**KNOXVILLE HISTORIC ZONING COMMISSION
STAFF REPORT - CERTIFICATE OF APPROPRIATENESS APPLICATION**

PROPERTY ADDRESS: 629 Luttrell St 37917

FILE NO.: 8-I-17-HZ

DISTRICT: Fourth and Gill H-1

DOOR FRAME
HEIGHT

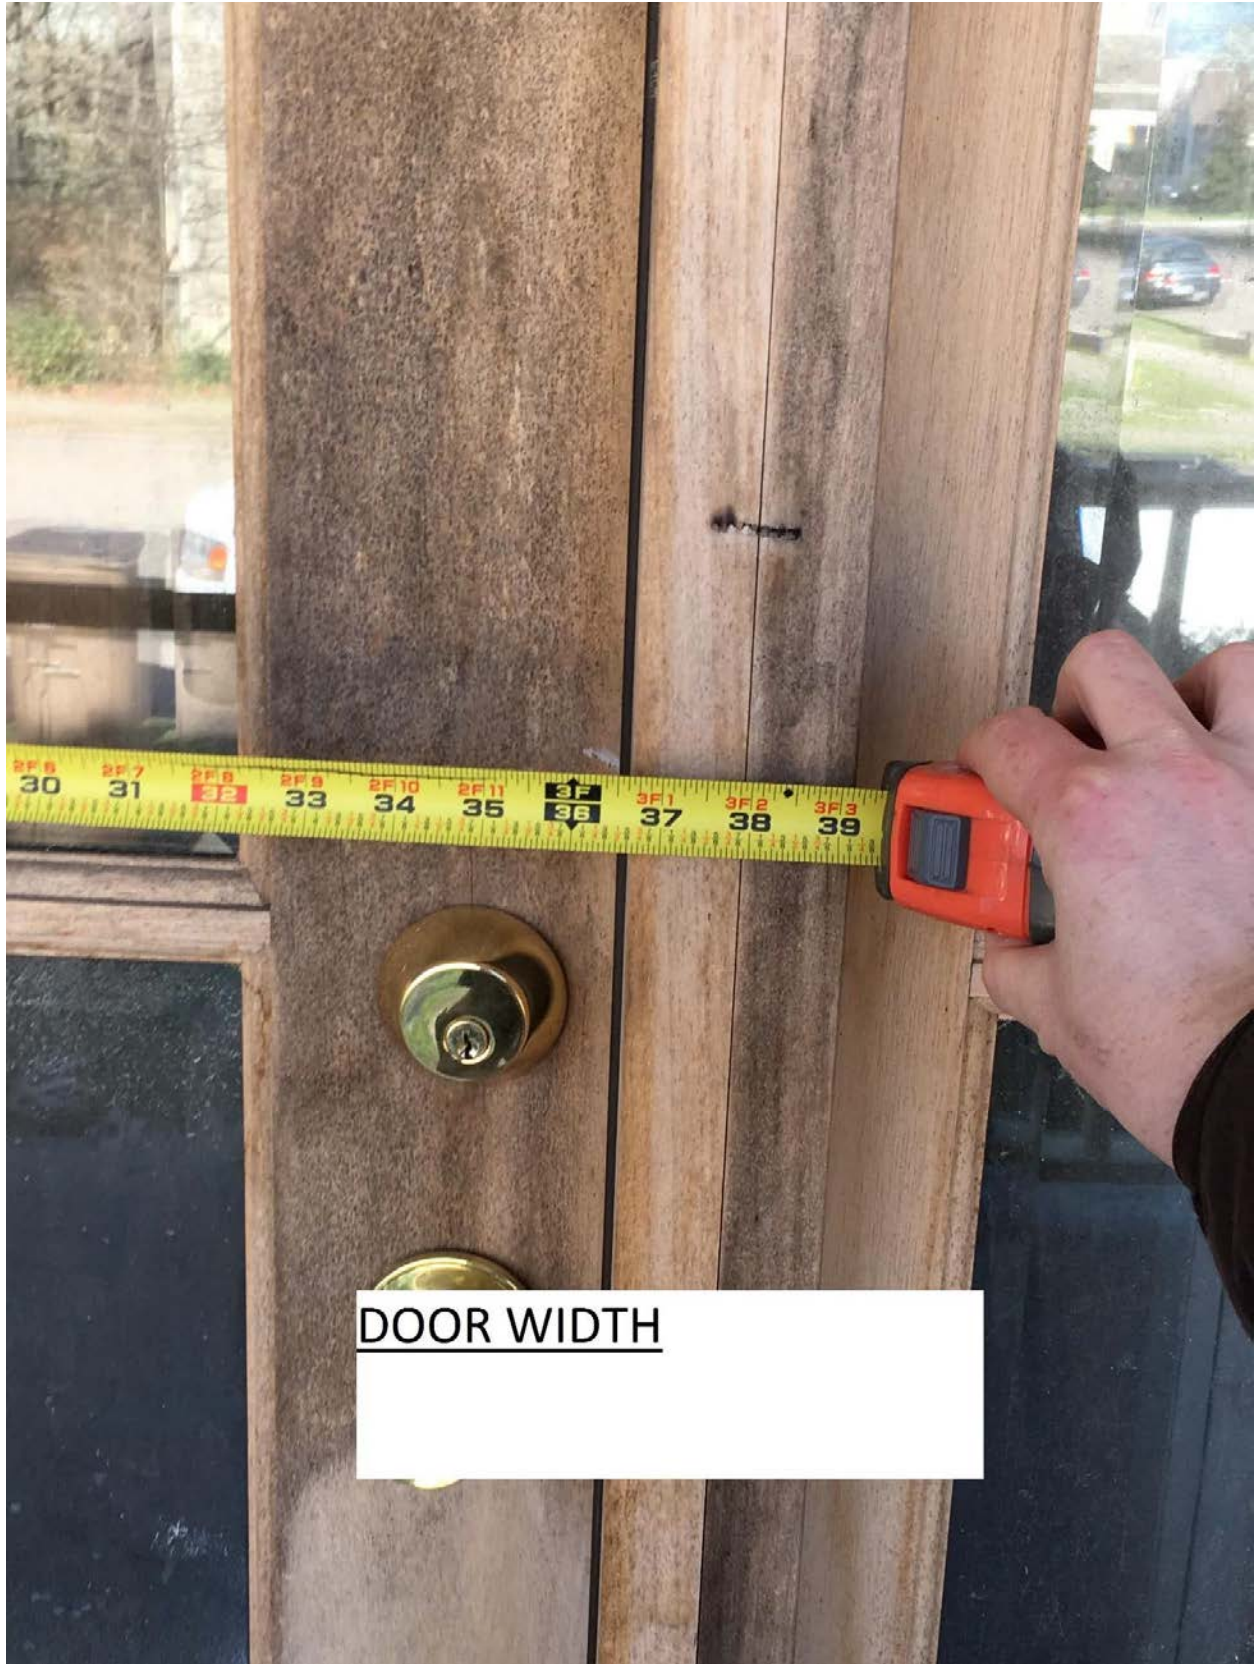
- 6) The ~9'-6" x 9'-6" wood porch roof support posts are appropriate to the style of the front porch.
- 7) The lowered height of the sidelight frames to ~7 feet is not appropriate since the height of the original sidelight frames measure 7'-5" to 7'-7" in height.

8) No evidence is provided that a transom existed over the front door; therefore, installing a transom would not appropriate if it could create a false sense of history. There is only about 7 inches of height remaining over the newly installed front door in which to install a transom, which is insufficient space to achieve an appropriate scale.

Approval of installing new front door and sidelights with the following conditions: 1) that the door be of a height to fill the original opening, or evidence be provided that a transom existed, and the door height be adjusted to accommodate it; and 2) that the door may be a half-light or 3/4-light wood door with no muntins; and 4) that the sidelights match the configuration as shown in the submitted photos; and 3) that the door knob be changed to a handle.

RAILING LEFT SIDE

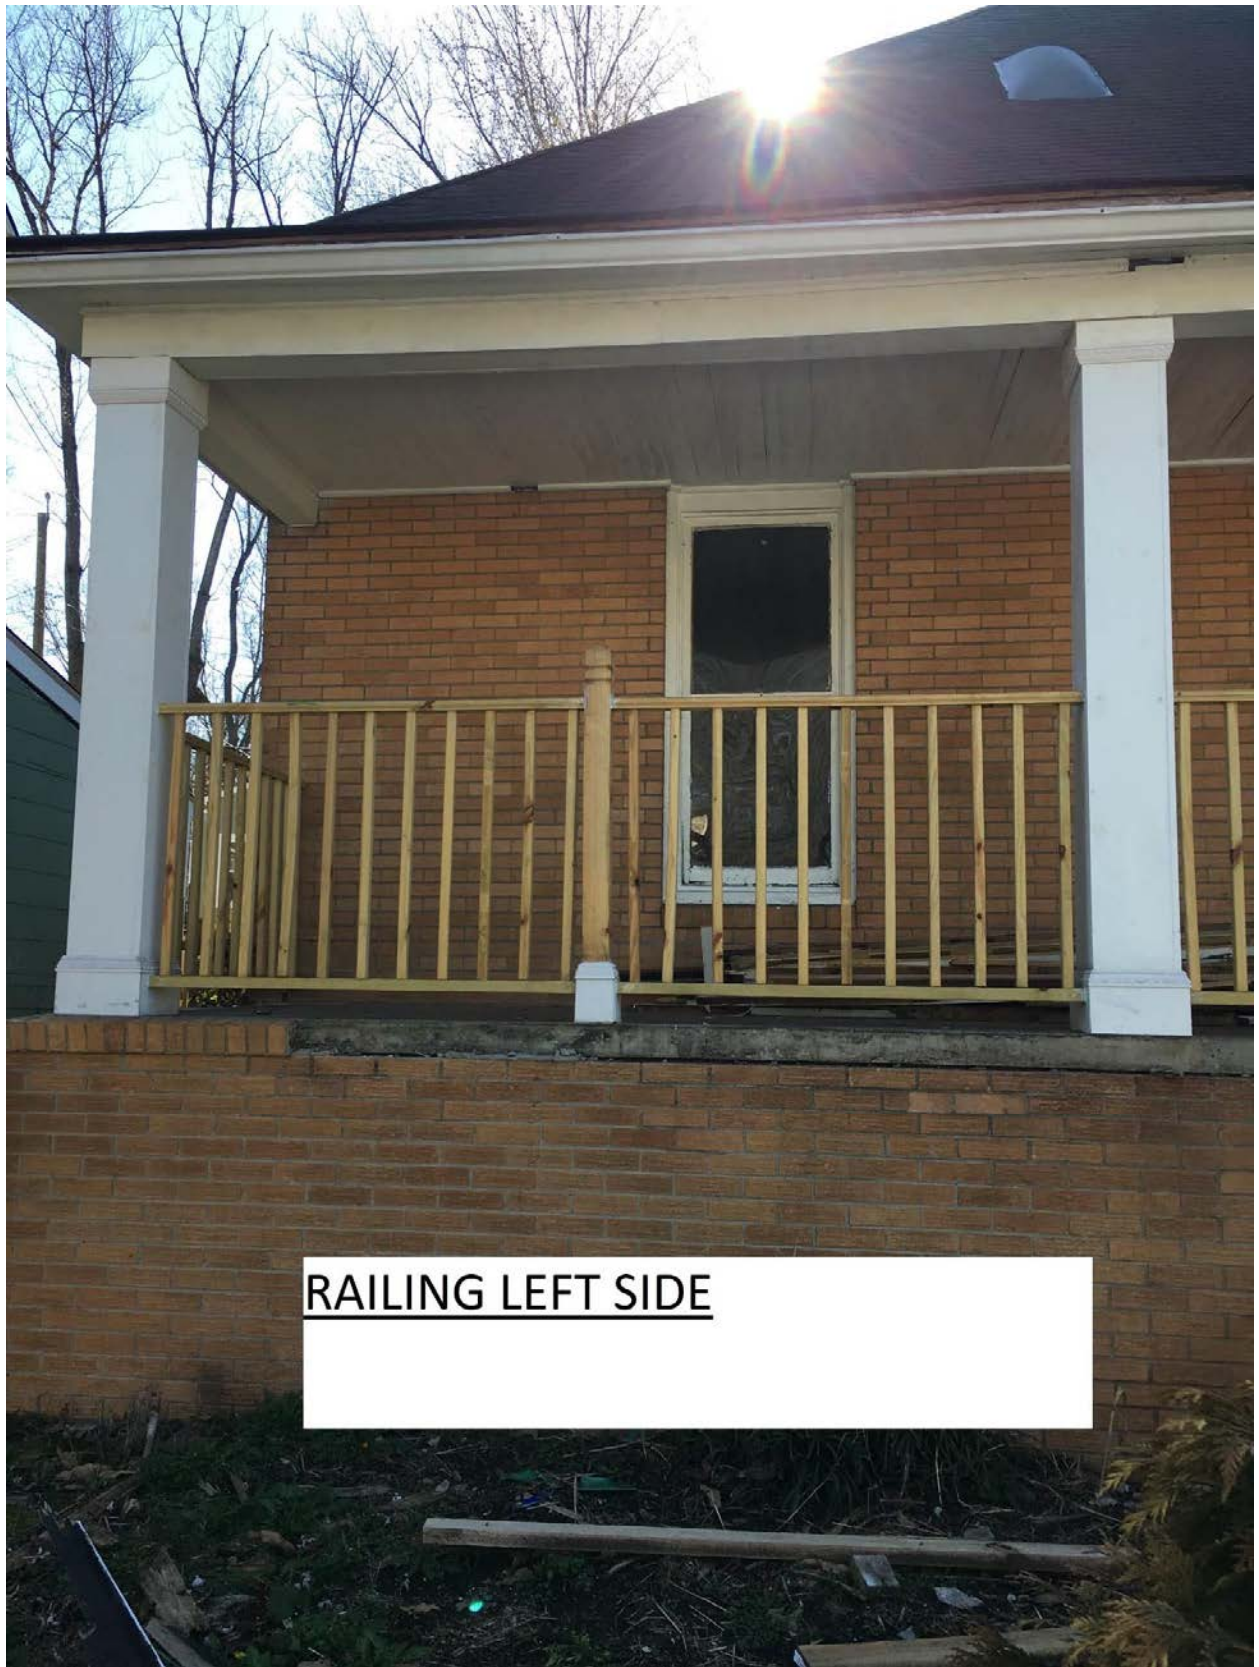
- 4) The height of the porch balustrade and step railing that are currently installed are not appropriate to the house. The balustrade/railing would be appropriate at 36"- high to meet building code, with newel posts at 39"- high.

- 5) The egg-and-dart molding at the base of the newels and the columns and at the top of the columns is not appropriate for the Queen Anne cottage style. A plain 1x 8-inch molding at the bottom and a plain 1x 6-inch molding at the top of the columns would be appropriate.

Staff recommends approval of the installation of a wooden balustrade and step rail with the following conditions: 1) height to be at 36-inches and to have a baluster spacing of 4 inches on center; and 2) remove the egg-and-dart molding.
